PLANNING AND DEVELOPMENT SERVICES

TO:	Municipal Planning Commission Subdivision Authority	DIVISION: 6
DATE:	May 12, 2021	APPLICATION: PL20210038
FILE:	07315033	
SUBJECT:	Subdivision Item – Creation of Two Residential Lots

APPLICATION: To create a ± 0.84 hectares (± 2.065 acres) new lot (Lot 1) with a ± 0.84 hectares (± 2.065 acres) remainder (Lot 2).

Maps of the current areas to help orient readers to the area of the proposal. This will help the reader to assess the affect of flooding.

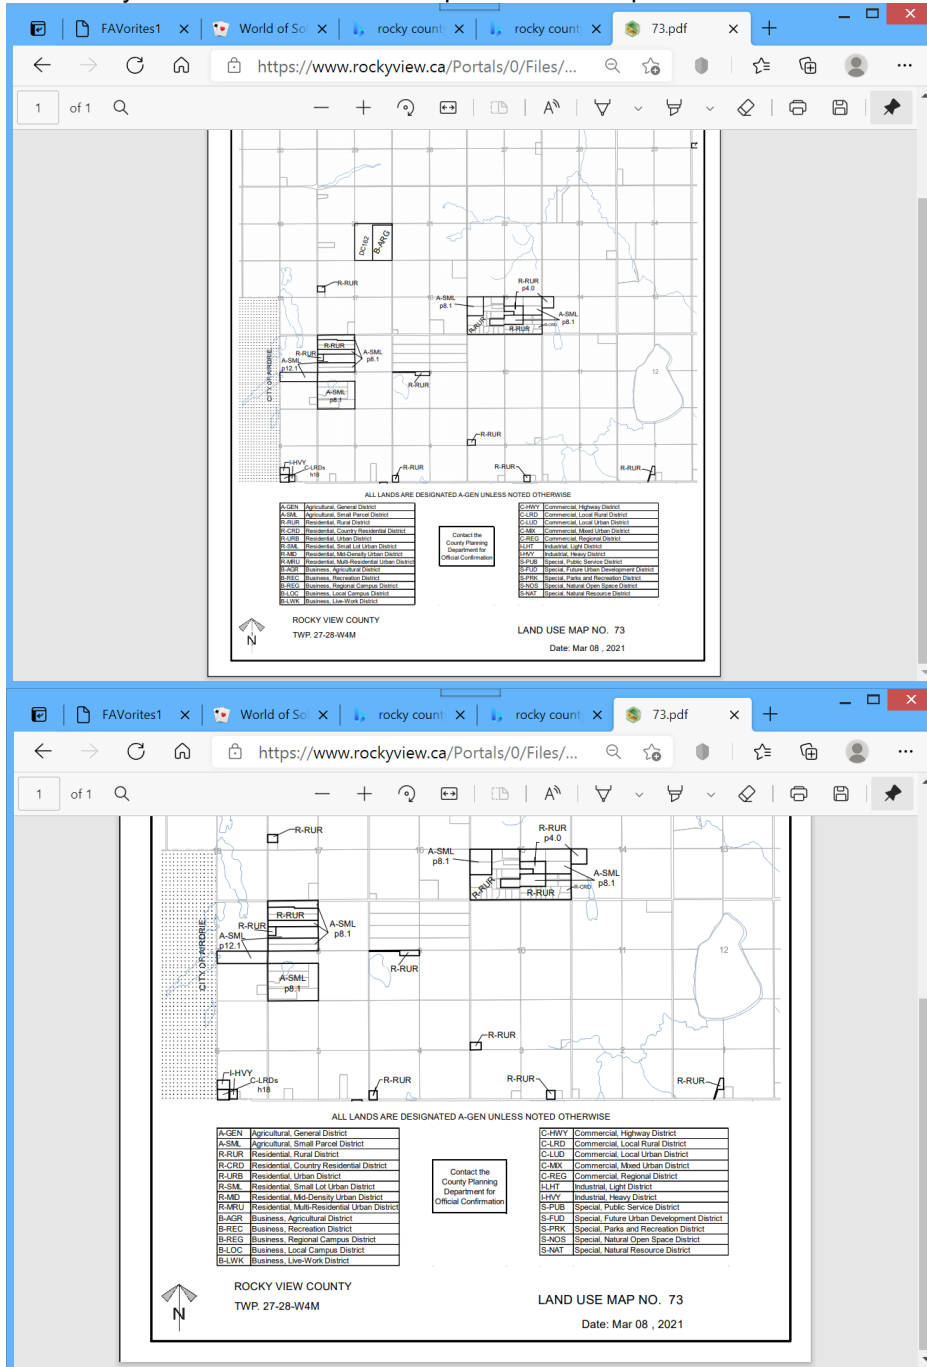
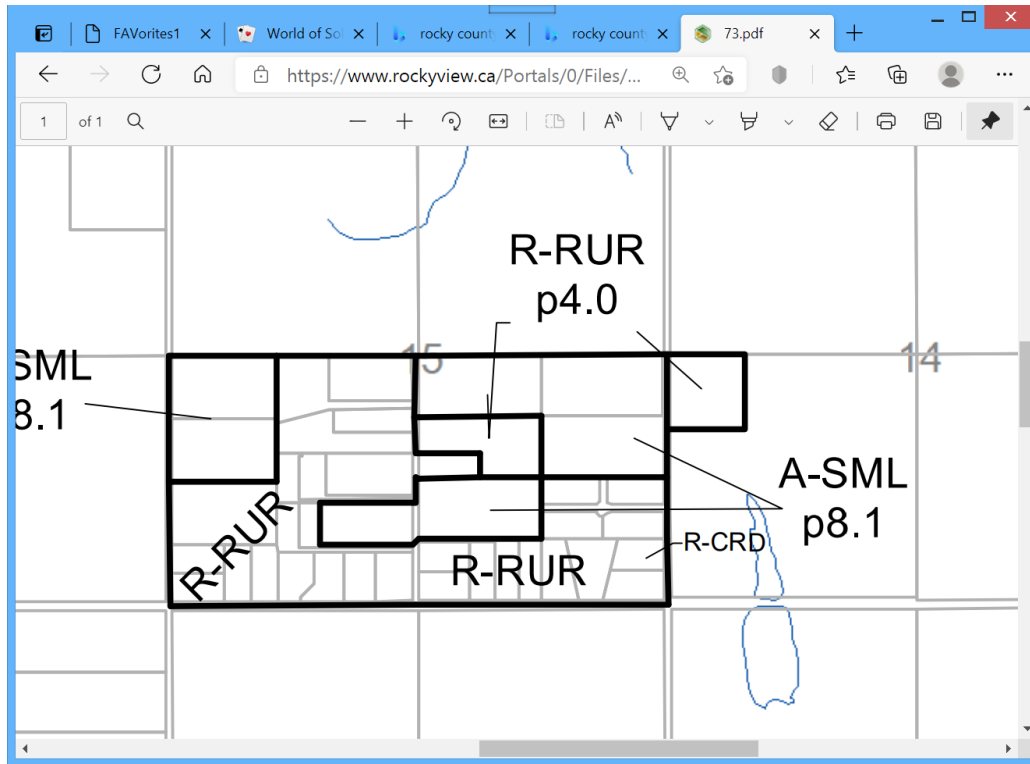
- The heavy black line indicates 'the block', an area that is drained by the ditch on the west side of RR 282, and is the same area indicated by the white heavy line in the documentation sent to us.
- The size of the slough in the lower right, just east of RR 282 and south of HWY 567 illustrates how large it can be in a wet year, whereas now, the size is much smaller. In fact, as of this date, it is dry.
- The property in question in the proposal is zoned as R-CRD.

A smaller part view of 'the block' illustrating Fox Meadow Vale and some of the lots just southward.

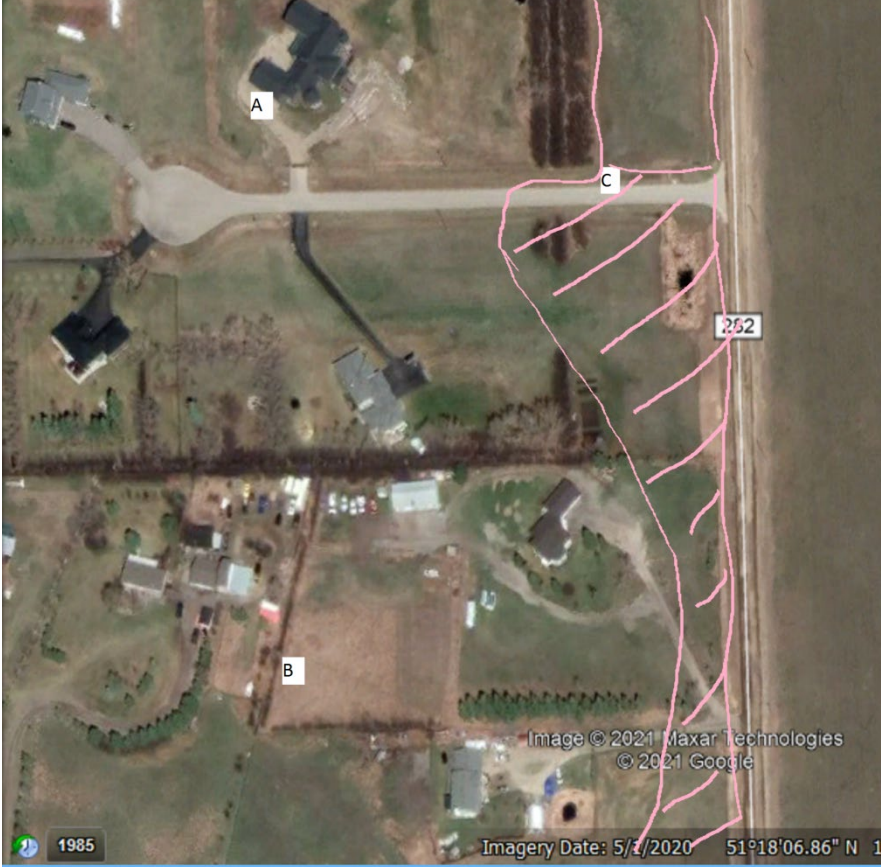
<p>Elevation of A is 3389 ft</p> <p>Elevation of C is 3376 ft</p> <p>Elevation of B is 3385 ft</p>
<p>Pink lines and hatching indicate high water levels.</p> <p>At point 'C', water was 6 - 8 inches deep at the pavement centre line.</p> <p>Note that C is a point on Fox Meadow Vale.</p> <p>Note that 'B' is a point on the new proposed lot and is located approximately at the highest elevation of that lot.</p> <p>Elevation difference between intersections of hwy 567 and range roads 283 and 282 is 223 ft. These points are 1 mile apart and water can move eastward in both the north and south ditches quite easily.</p> <p>However, the elevation difference along 282, from hwy 567 to the creek almost a mile north, is only 50 ft. This fact indicates that water moves much slower from south to north and thus helps accounts for the flooding that occurred.</p> <p>One fact that is most important regarding runoff, is that in the wet years of 2013/4, neither may NOT have been the wettest year in recent history! As well, since the west ditch of 282 seems to be the only water course draining the whole half section in question, plus an unknown portion of the section south of this section, we must be very cautious in making changes that will cause more devastating flooding in future wet years.</p> <p>Note: Elevations were taken from Google Earth.</p>

Other examples of wet vs. dry year conditions.

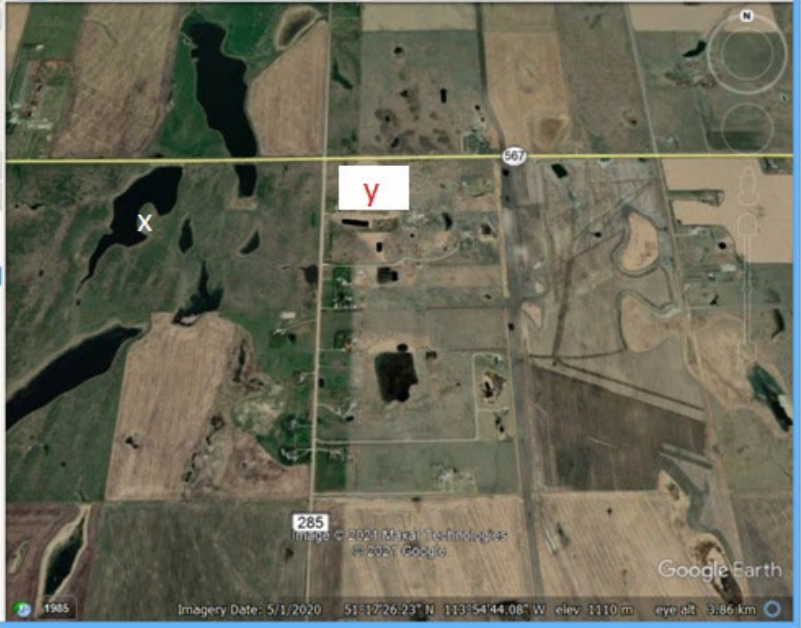
This is a Google Map image date 2020 May	
	<p>The white 'x' indicates a knoll in the slough that was actually an island back in the wet years.</p> <p>The white square containing a red 'y' was filled with water. Mac told his kids at the time, that there must have been 'dry' years because there was a fence (and is now) through the water and parallel to the highway.</p>
These observations were made by us since nearly every day we drove from Airdrie to our new lot during our building phase beginning in 2011.
